# VAN BUREN CORRIDOR PLAN

## RESPONSE TO COMMENTS ON THE DRAFT VAN BUREN CORRIDOR PLAN

### Van Buren Steering Plans

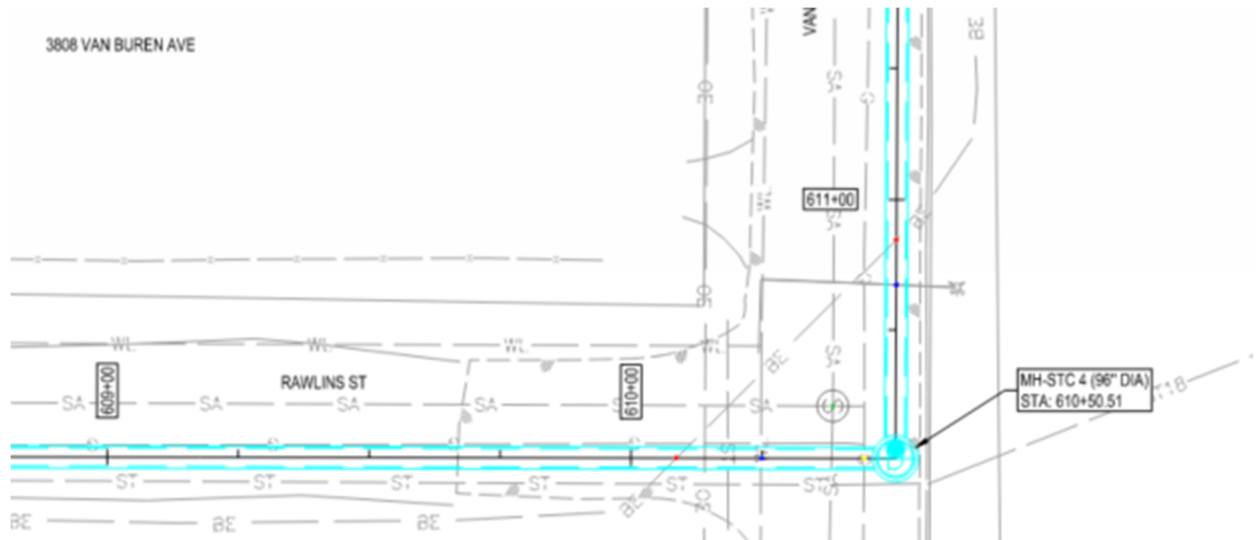
4. Are there parallel waterlines running at 20+00?

There's not supposed to be. Thanks for catching this. The extra line has been removed.
